SUBJECT: WOLF CREEK GENERATING STATION - AMENDMENT NO. 120 TO FACILITY
OPERATING LICENSE NO. NPF-42 (TAC NO. MA1294)

AMENDMENT TO FACILITY OPERATING LICENSE

SAFETY EVALUATION BY THE OFFICE OF NUCLEAR REACTOR REGULATION
RELATED TO AMENDMENT NO. 120 TO FACILITY OPERATING LICENSE NO. NPF-42

FIGURE 3.9-1
 MINIMUM REQUIRED FUEL ASSEMBLY BURNUP AS A FUNCTION OF
 INITIAL ENRICHMENT TO PERMIT STORAGE IN REGIONS 2 AND 3

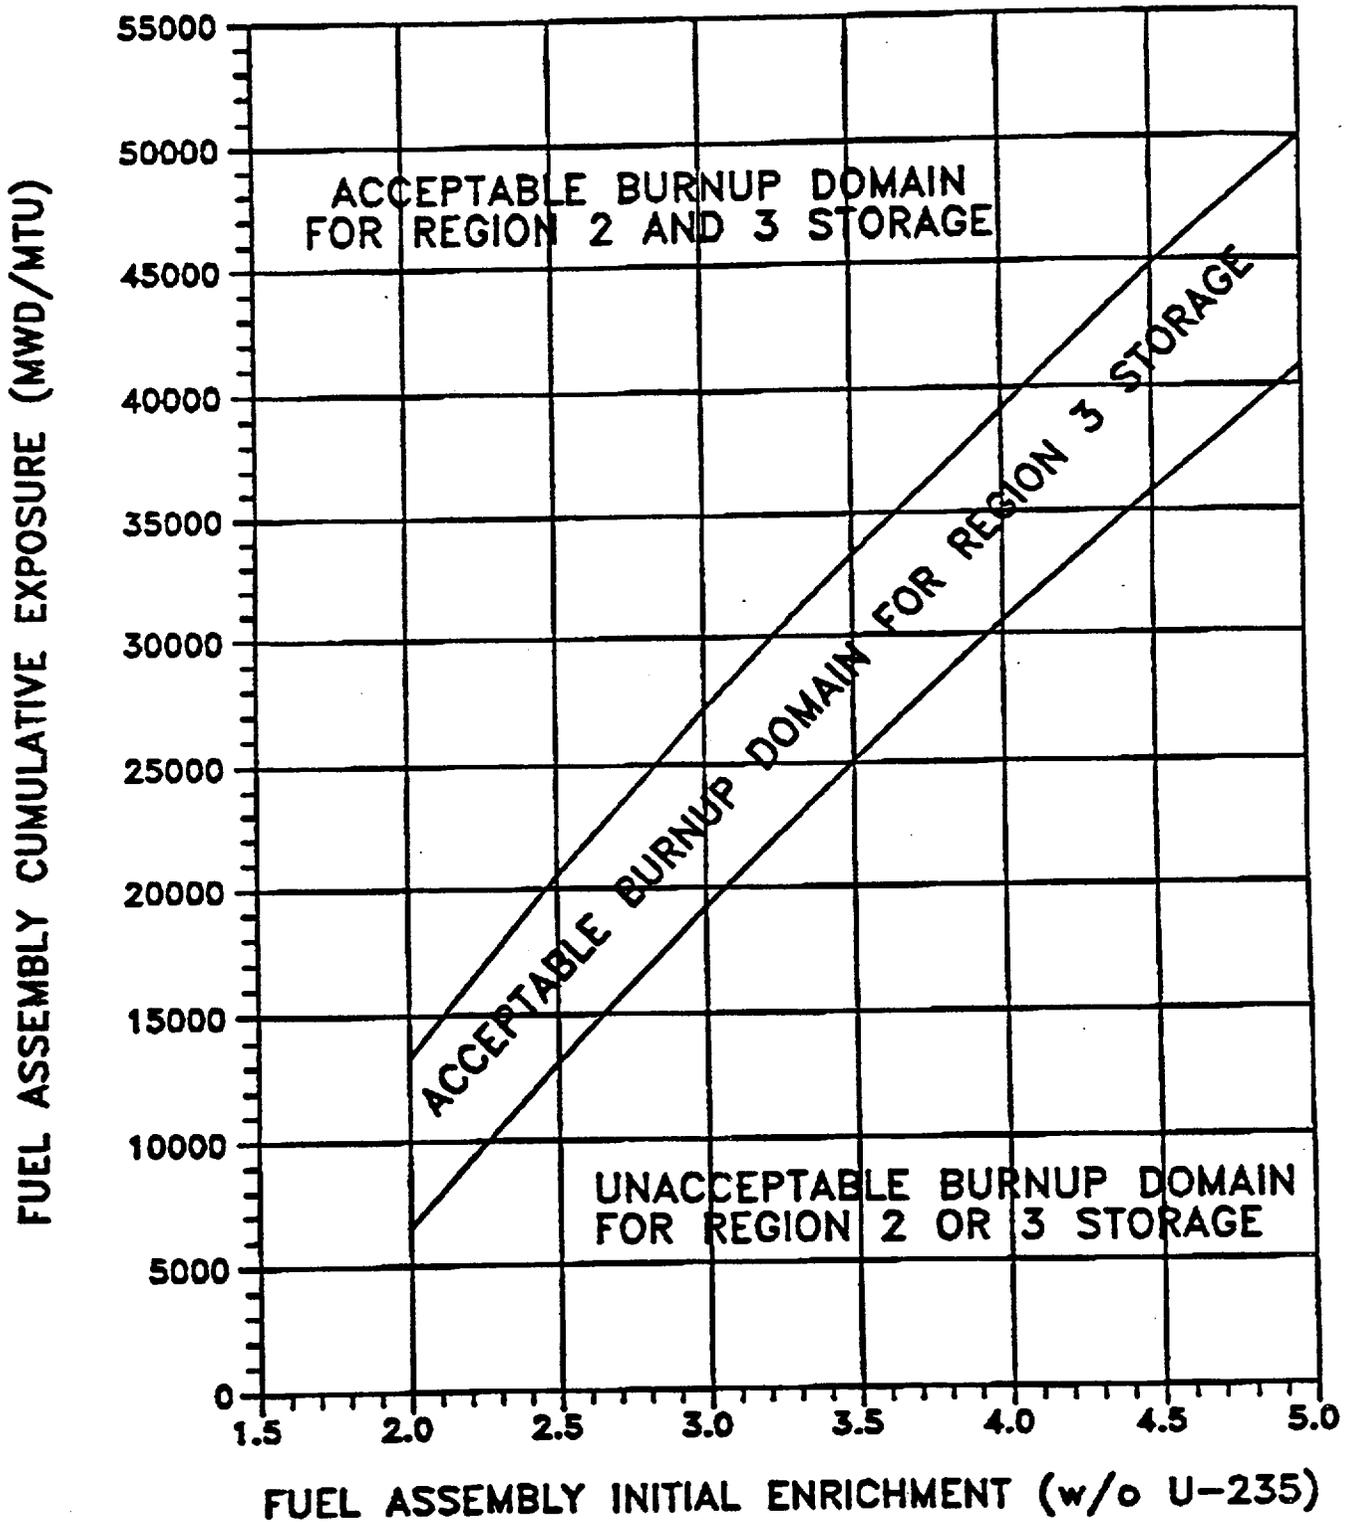
Proposed TS Figure 3.9-1 shows that Regions 2 or 3 can safely accommodate fuel of various initial enrichments up to 5.0 w/o U-235 and discharge burnups provided the combination falls within the acceptable domain illustrated by the upper line. Assemblies meeting the burnup requirements of the lower line may only be stored in Regions 1 or 3. This reactivity equivalencing method is the standard method used for storage rack reactivity evaluations and is acceptable.

1. TS 3.9.12 has been revised to reflect the conditions required for fuel assembly storage in Regions 1, 2, and 3. The associated TS Figure 3.9-1, which shows the minimum required fuel assembly burnup as a function of initial enrichment for allowed storage in Regions 2 and 3, has been revised.

2. TS 5.6.1.1a has been modified to allow spent fuel storage of assemblies with maximum nominal enrichment of 5.0 w/o U-235 in Region 1 and storage in Regions 2 and 3 based on acceptable combinations of initial enrichment and discharge exposure as shown in Figure 3.9-1.
